Melrose Commons North RFP Addendum I
RFP issue date: September 5, 2008
Addendum I issue date: October 24, 2008

Contents of the Addendum

Attachment 2

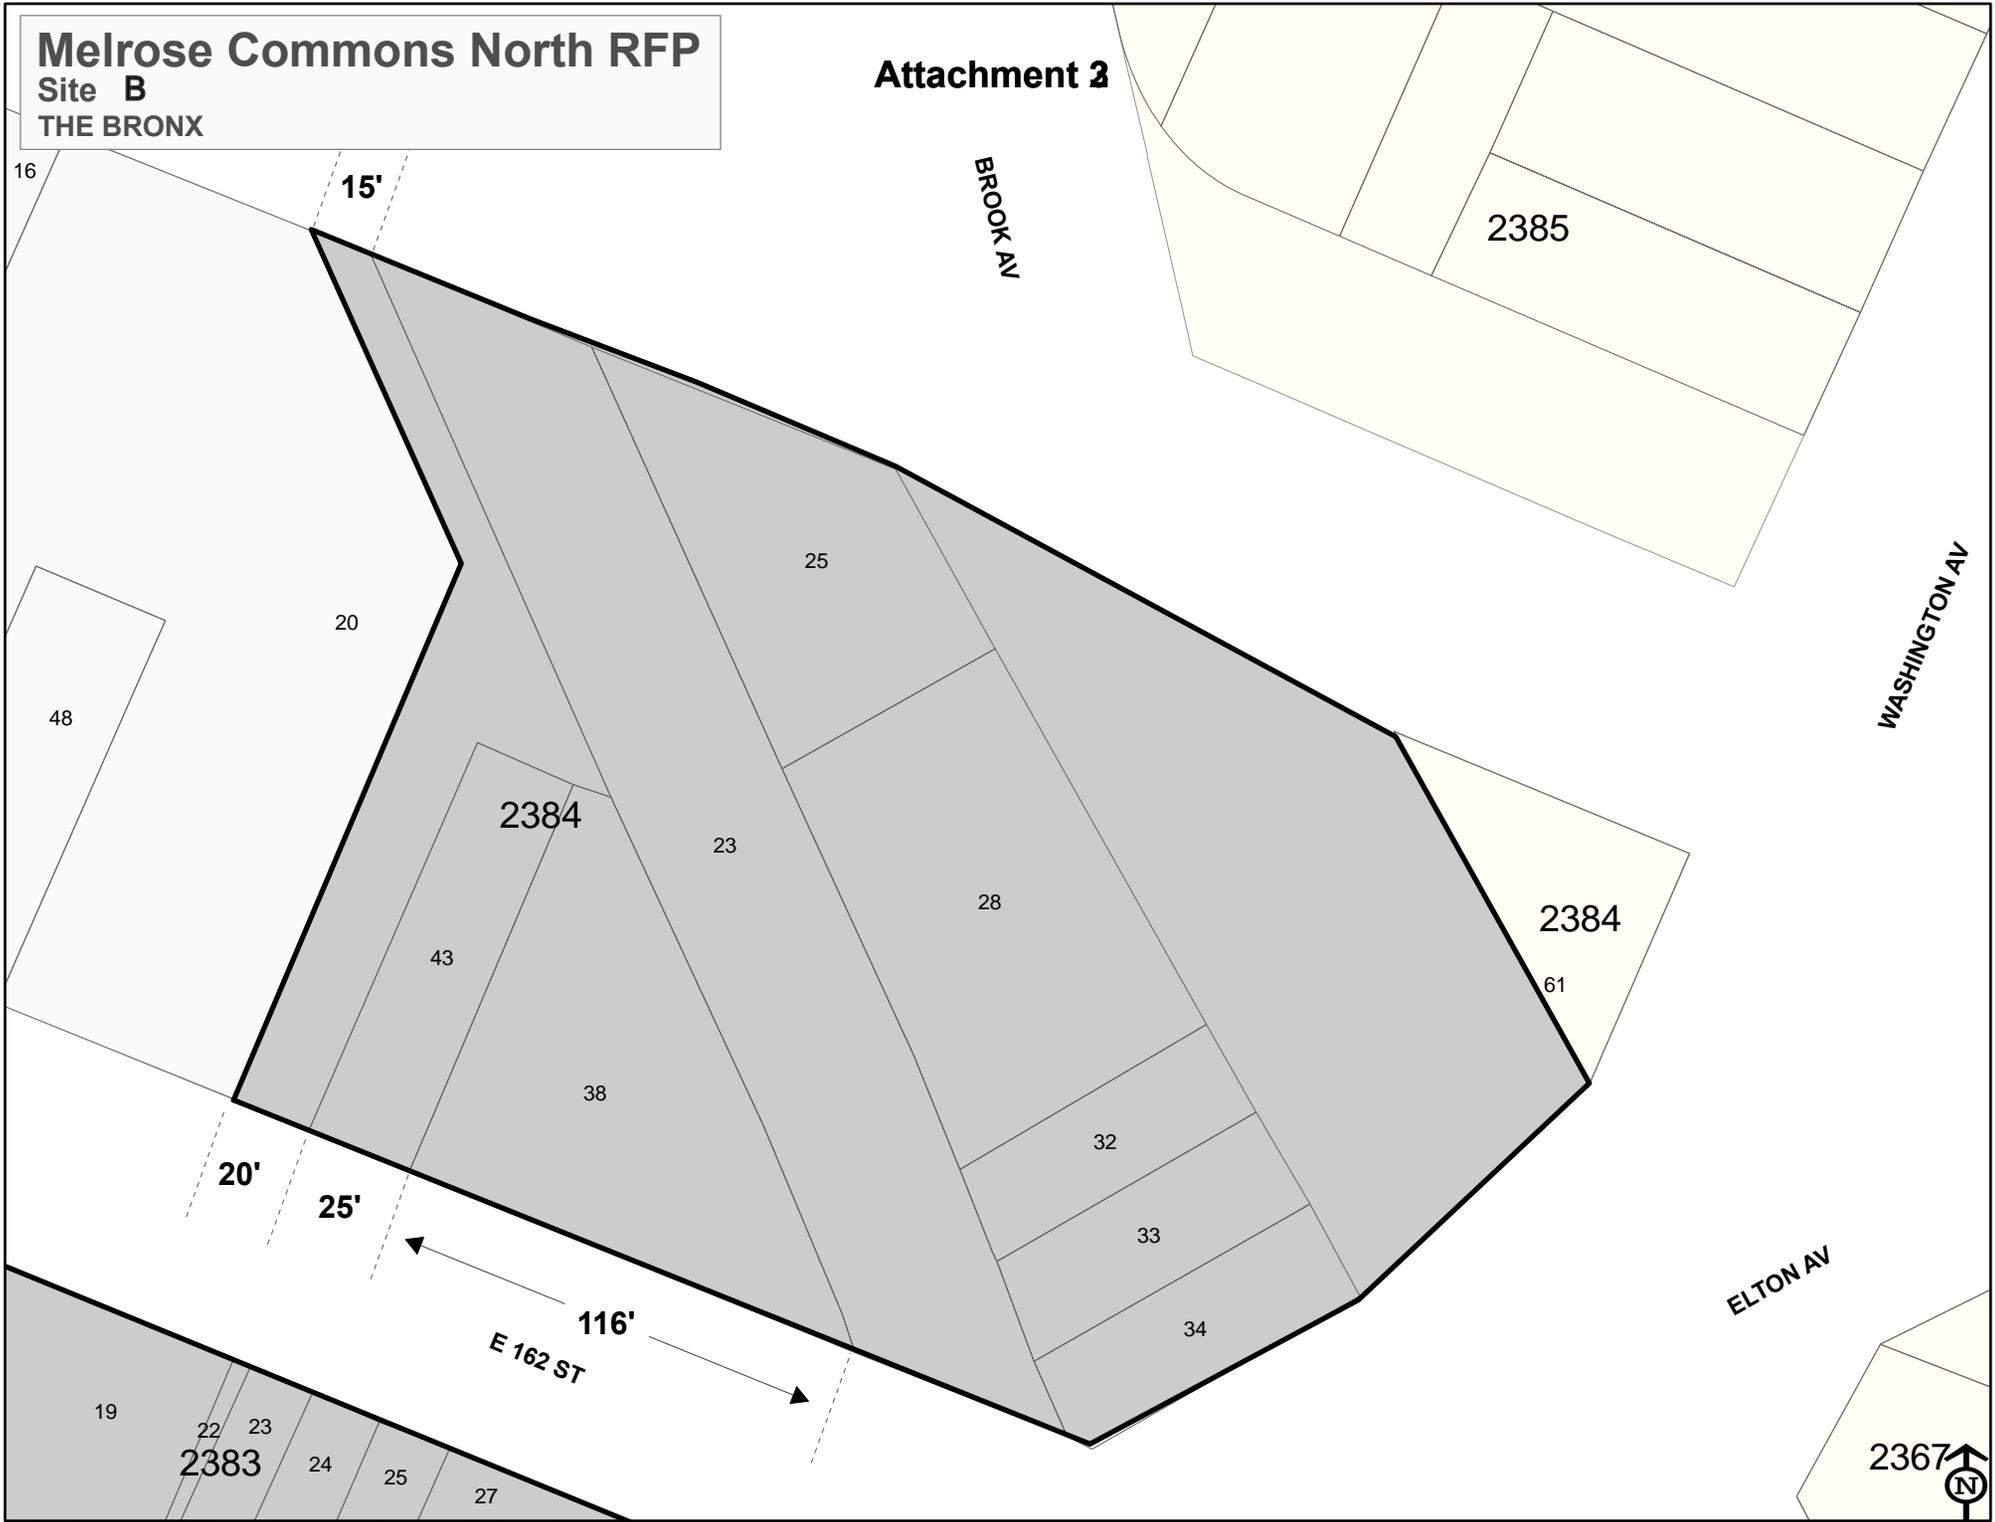
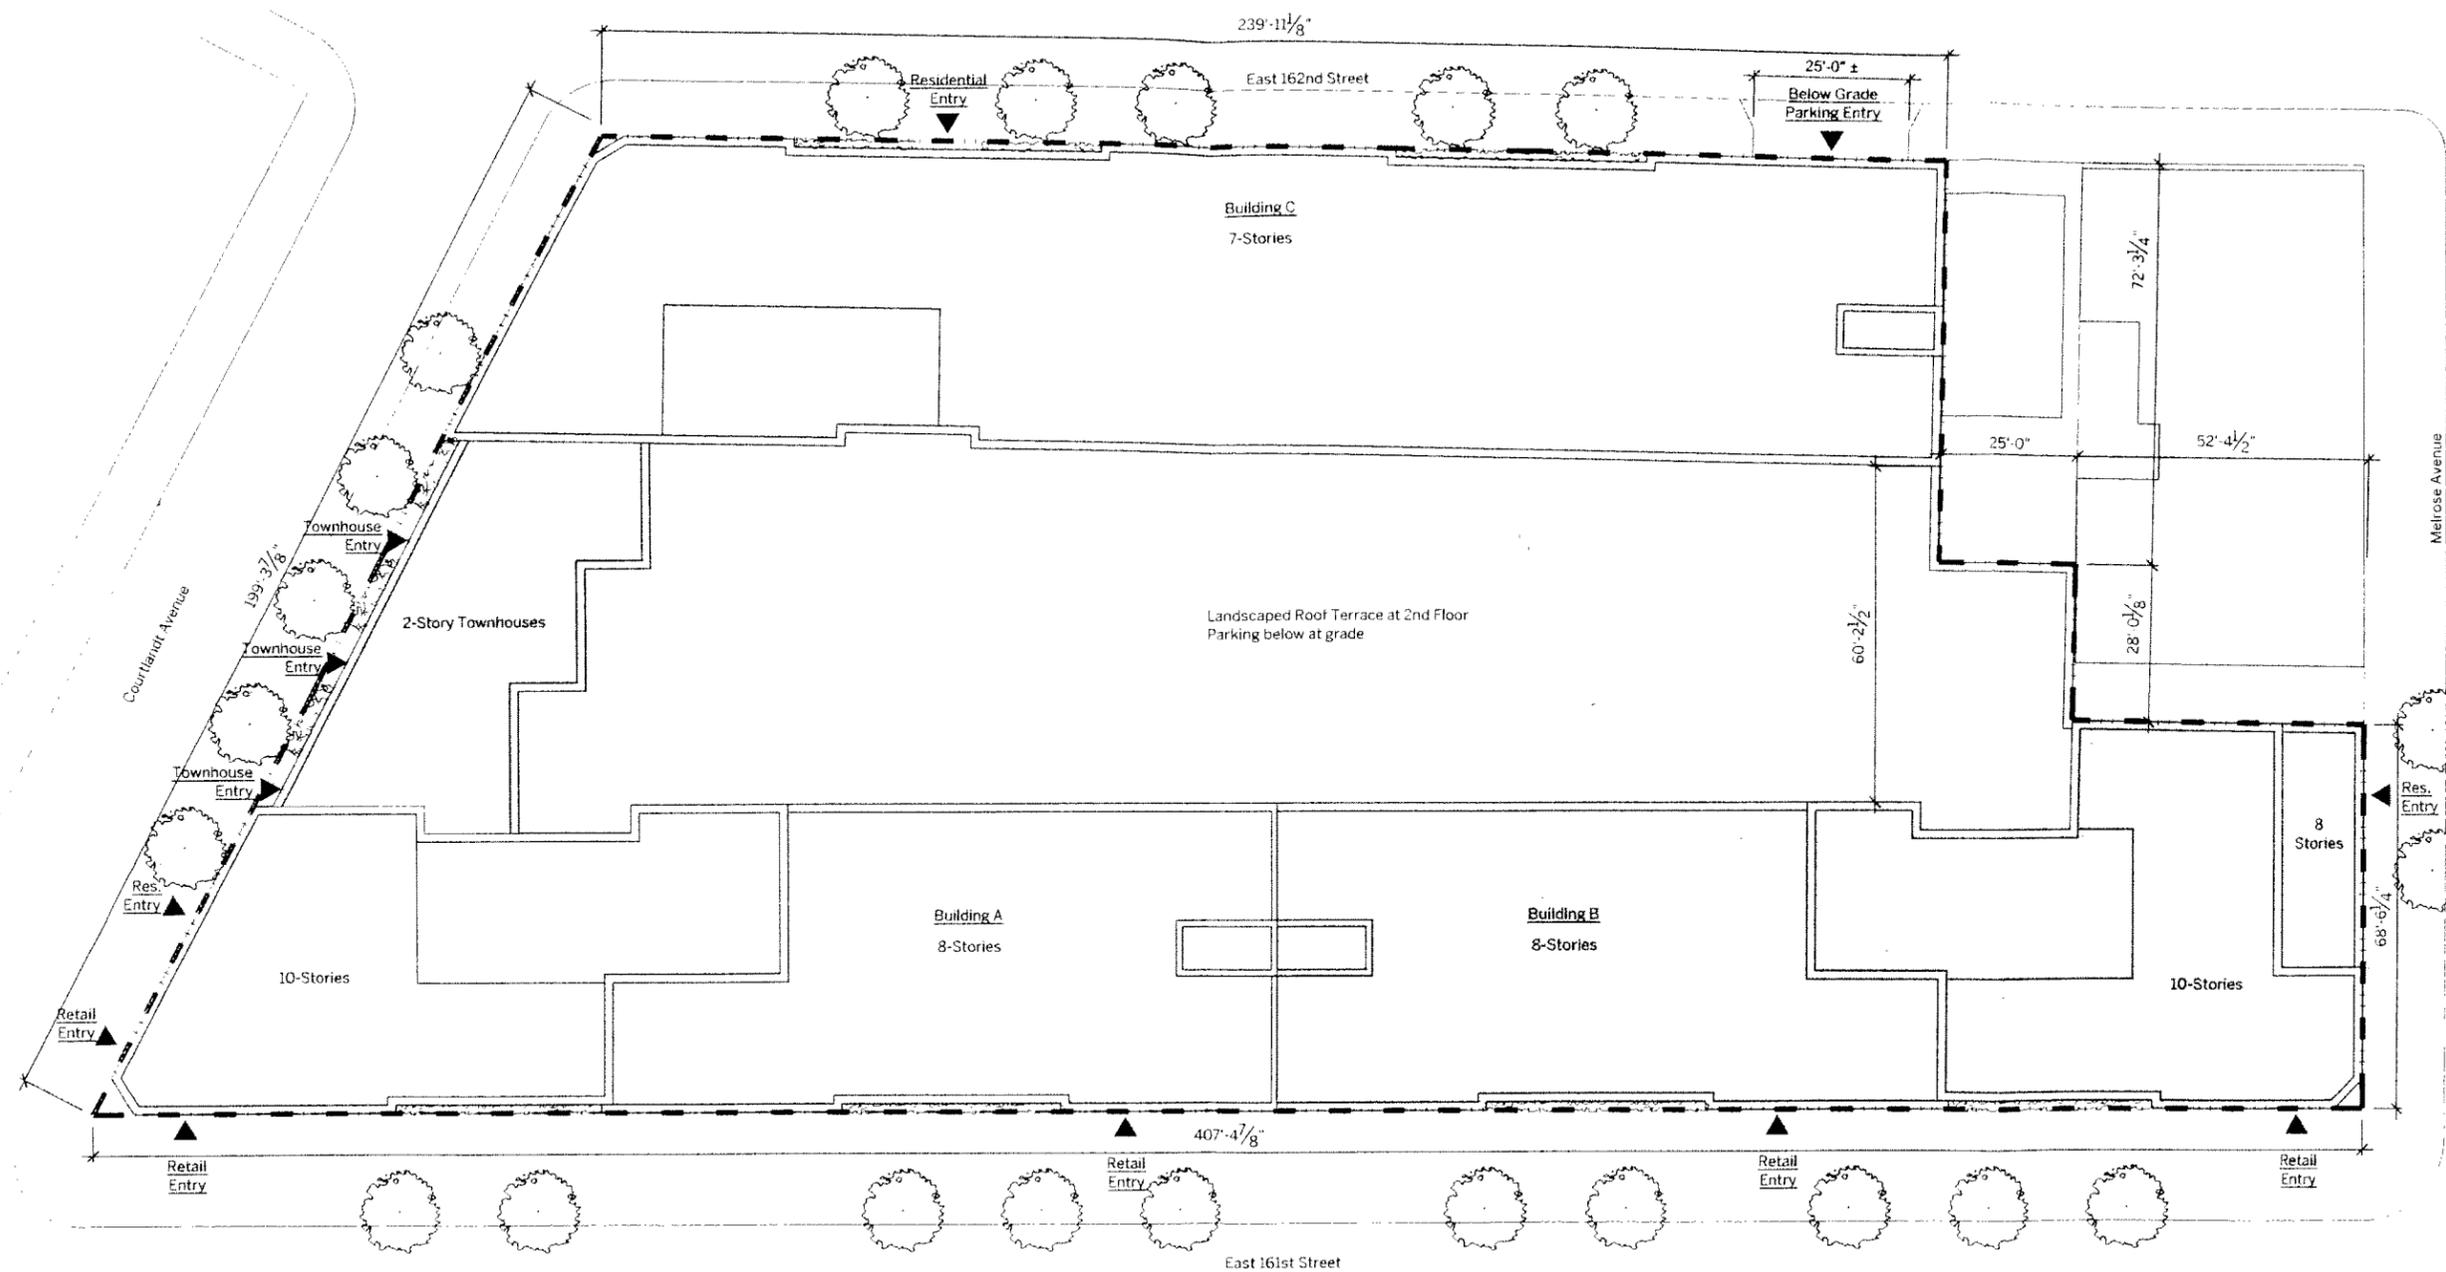
The total lot area of Site B, including the Brook Avenue Road bed, is approximately 53,000 square feet. [See Attachment 2 and the response to question 28 below for more details on the dimensions of Site B.]

28. For Site B, my estimate of the total combined square footage is 55,000 square feet. The RFP has an estimate of 49,000 square feet. Please clarify.

The RFP was mistaken and the correct square footage for Site B is approximately 53,000 square feet. Attachment 2 gives more detail on the dimensions of Site B. The Development Site border extends along East 162nd Street approximately 20 feet west of the western edge of the former lot 43. The border extends north towards East 163rd Street parallel to the western border of lot 43. Site B's border angles to the west and this portion is parallel to the western edge of lot 23. For the purposes of the RFP proposal, Applicants should assume a distance of 15 feet between the angled portion of the Site B boundary and lot 23's western boundary. The precise measurement of this distance will be determined by the engineering needs of the project and be negotiated with the Parks department.
